Re: Pre-Application Assessment Form
Pre-Application number: PE2022-01082

Pre-Application Assessment

Application Number: PE2022-01082
Site Address: 6623 BOWNESS RD NW
Community: BOWNESS
Applicant: Sholdice, Trevor

6. Bowness Area Redevelopment Plan

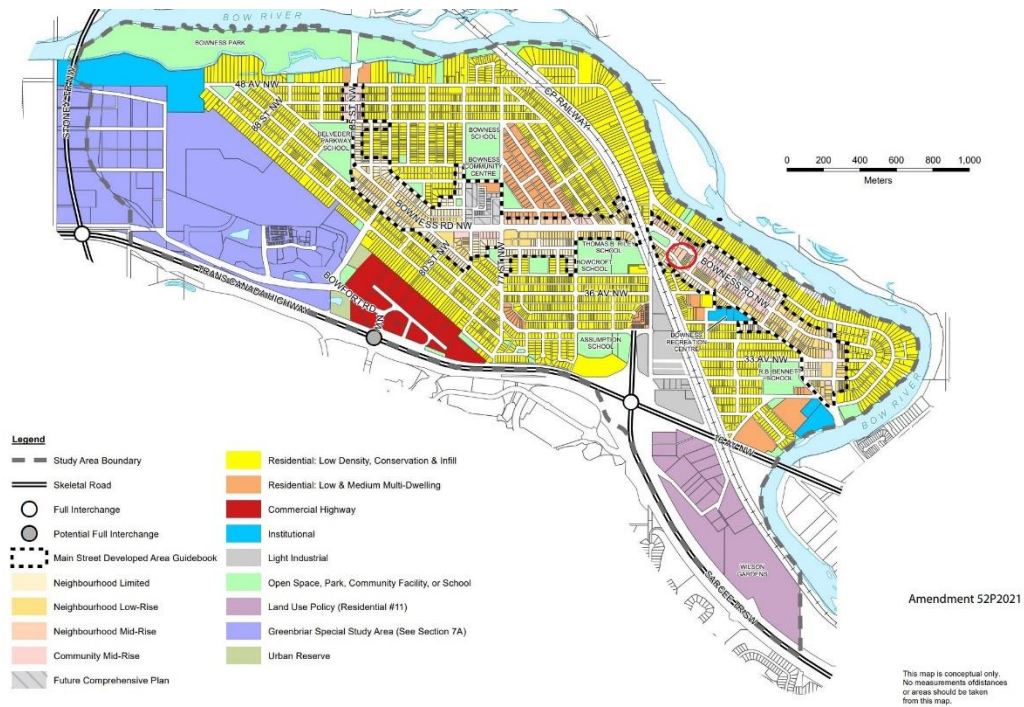
Map 2 of the Bowness Area Redevelopment Plan provides land use policy areas for the Bowness Community. The subject site is defined within this plan as Residential: Low & Medium Multi-Dwelling.

The subject site is also within the Bowness Main Street area. A Main Street allows for a wider variety of uses and mixed housing options to support higher density of development necessary to support these varied retail and business uses. Subject parcel along Bowness Rd NW has been designated as R-C2 since the inception of LUB 1P2007. As part of the Bowness Main Street initiative, development along Bowness Road is designated as M-C1 Multi-Residential - Contextual Low Profile and M-C2 Multi-Residential - Contextual Medium Profile.
